Access Compliance Report

Public Rights-of-Way

Intersection ID: 30498	Main Street: BEDDINGFIELD_DR	Cross Street: ORCHARD GRASS_CT	Location: W
ADA ID: BE74ADF0E76E	Ramp Type: PerpDiag	Initial Pass/Fail: Fail	Overall Compliance: No
Severity Score: 8.75			
Codes/Mitigation Info/Possible Solution		Field Measurements/Component Compliance

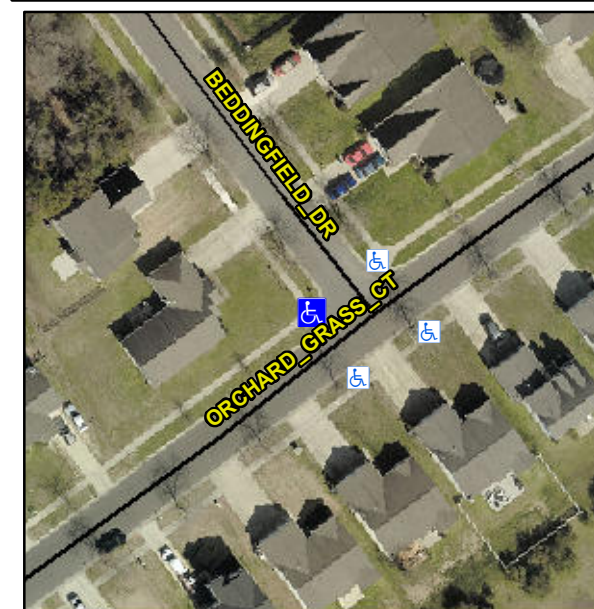
Remove & Replace Curb Ramp With Two New Directional Ramps or Equivalent.

R304.5.1
